# UNITED STATES PATENT AND TRADEMARK OFFICE

<b>Office Action Summary</b>	<b>Application No.</b> 10/521,921	<b>Applicant(s)</b> GIBBS, RODERICK JOSEPH	
	<b>Examiner</b> FANNIE KEE	<b>Art Unit</b> 3679

## **DETAILED ACTION**

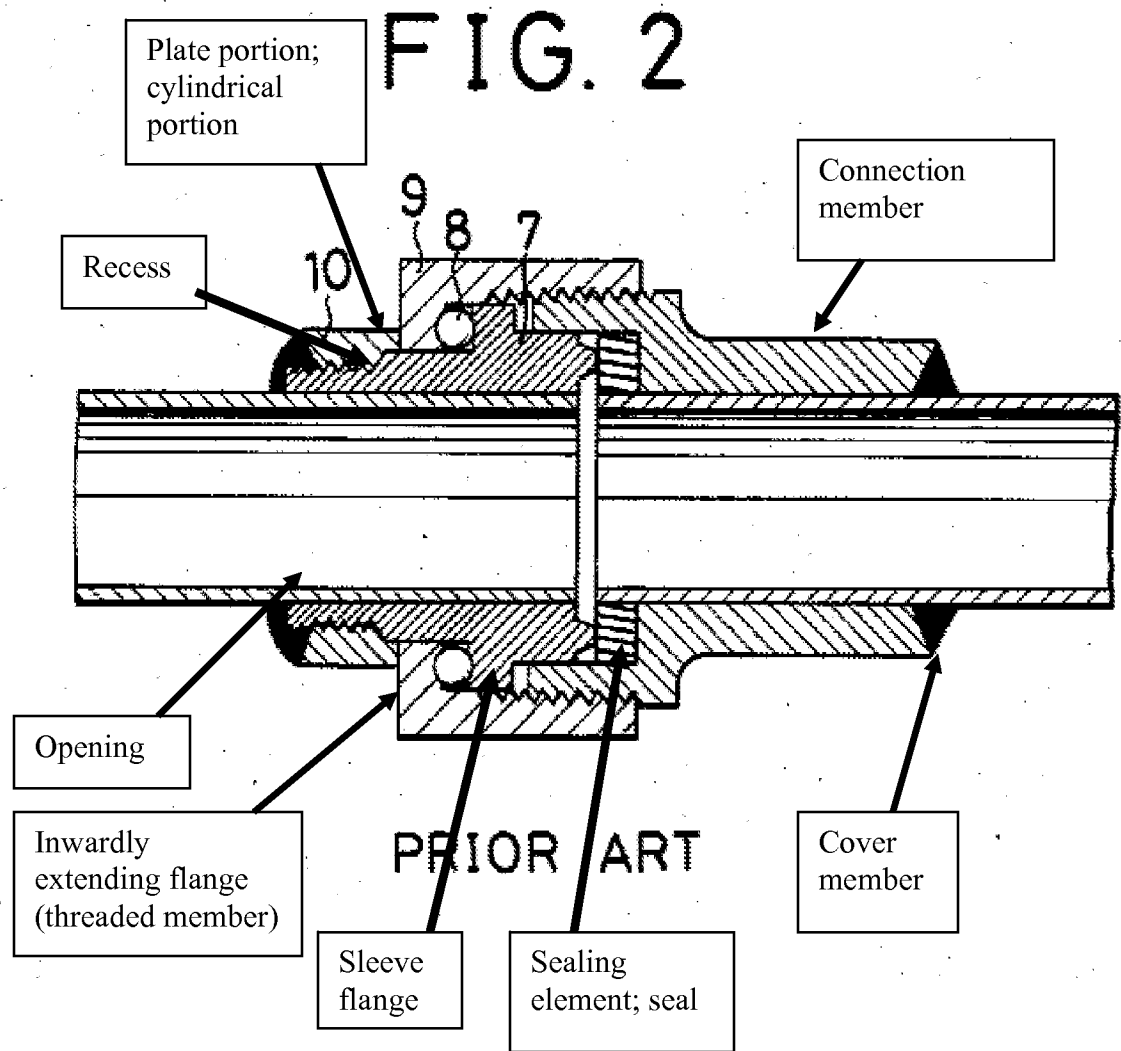
With regard to claim 1, and as seen in Figure 2 below, Totani discloses a fluid connection assembly for establishing a connection with a fluid supply pipe extending from a rear face of a panel to a front face of the panel, the assembly comprising a connection member engageable with the fluid supply pipe at the front of the panel; and means for connection of the fluid pipe to the connection member, comprising a support member (10) adapted to be fixed to the panel at the front face thereof, a threaded member (9) supported by the support member and rotatable relative to the support member for engaging the connection member, and a compression fitting operable from the front of the panel and comprising a sealing element deformable responsive to tightening of the threaded member to establish a seal between the fluid supply pipe and the connection member.

With regard to claim 2, and as seen in Figure 2 above, Totani discloses the connection member having screw threaded engagement with the threaded member (9), and the compression fitting includes the sealing element deformable between the threaded member and the connection member to establish a seal between the fluid supply pipe and the connection member.

With regard to claim 3, and as seen in Figure 2 above, Totani discloses the connection member being adapted to have a shower head or hose connected to it.

With regard to claim 4, and as seen in Figure 2 above, Totani discloses a cover member adapted to engage with the assembly and to conceal the assembly.

With regard to claim 5, and as seen in Figure 2 above, Totani discloses the support member (10) comprising a plate portion *abutting the front face of the panel* and a recess *that extends past the front face of the panel toward the rear face of the panel*.

With regard to claim 6, and as seen in Figure 2 above, Totani discloses a sleeve (7) disposed between the fluid supply pipe and the recess of the support plate, wherein the sleeve includes a flange that corresponds with a flange of the threaded member for holding the threaded member in a desired axial position relative to the support plate while providing for rotation of the threaded member relative to the support plate.

With regard to claim 7, and as seen in Figure 2 above, Totani discloses the sealing element being disposed about the fluid supply pipe between the sleeve on a first axial end and the connection member.

With regard to claim 8, and as seen in Figure 2 above, Totani discloses the threaded member (9) comprising a threaded nut including an inwardly extending flange corresponding to the flange of the sleeve for holding the desired axial position of the threaded member onto the support.

With regard to claim 10, and as seen in Figure 2 above, Totani discloses a fluid connection assembly comprising:

- a support (10) attachable to a panel that includes an opening for a fluid supply pipe;
- a threaded member (9) supported on the support and rotatable relative to the support;
- a conduit engageable with the threaded member for directing water to a hydraulic device;
- and
- a seal for assembly to the fluid supply pipe that is compressible responsive to the conduit being threadably received by the threaded member.

With regard to claim 11, and as seen in Figure 2 above, Totani discloses the support plate including a sleeve (7) disposed between the fluid supply pipe and the opening in the support for rotatably supporting the threaded member.

With regard to claim 12, and as seen in Figure 2 above, Totani discloses the seal being disposed around the fluid supply pipe and between the sleeve and the conduit.

With regard to claim 13, and as seen in Figure 2 above, Totani discloses the support including a face portion *that abuts the panel* and a cylindrical portion *that extends through the panel about the fluid supply pipe*.

With regard to claim 14, and as seen in Figure 2 above, Totani discloses the face portion being attachable to the panel.
